Florida Department of  
Environmental Protection  
Inspection Checklist

Facility Name: J.E.D LANDFILL (F/K/A OAK HAMMOCK DISPOSAL)

Construction Completion Certification Inspection for Landfill - Class I facility

Leachate Issue at Intercell Berm

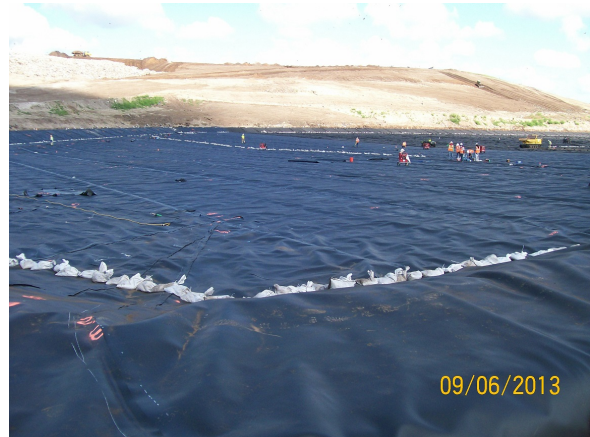
The intercell berm toward Cell 6 was experiencing a leachate back-up issue. The issue was temporarily being dealt with by supplying manpower to remove soil/silt from the length of the tie-

in to promote drainage of leachate down into Cell 6 (this was being done at the time of this inspection) and/or pumping it out. The issue was later addressed by installing a geomembrane flap along the intercell berm to restrict the potential cross flow of leachate from Cell 6 into Cell 9 during construction. This corrective action measure is described in the certification report section 7.3 Geomembrane Flap at Intercell Berm, dated October 31, 2013.
